**GOVERNMENT OF THE DISTRICT OF COLUMBIA
DEPARTMENT OF TRANSPORTATION**

MEMORANDUM

SUBJECT: **ZC Case No. 14-04** – Professional Associates and International Finance Corporation

Figure 1 Site Design and Access (Source: Gorove/Slade Associates)

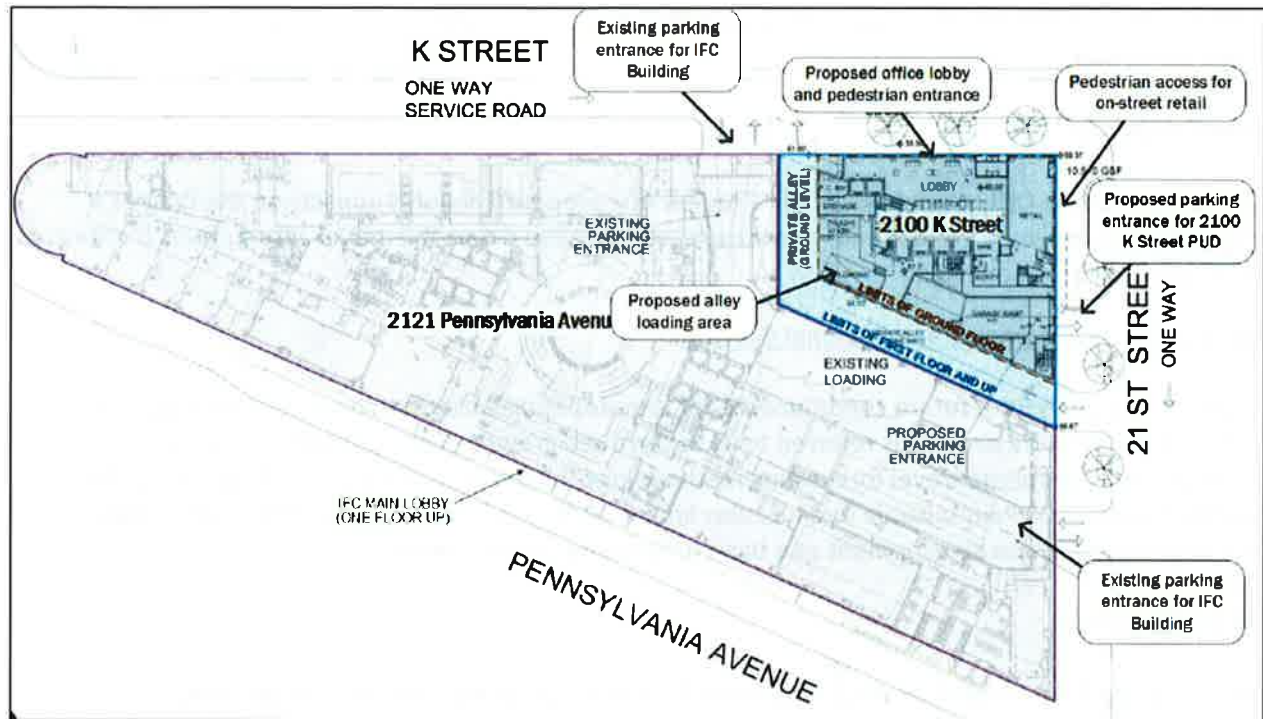
The Applicant proposes vehicular parking access to a 48-space below-grade parking garage off of a single curb cut on the west side of 21st Street. While DDOT prefers vehicle access from an alley, DDOT finds the proposed access is appropriate for this location due to site constraints of the alley.
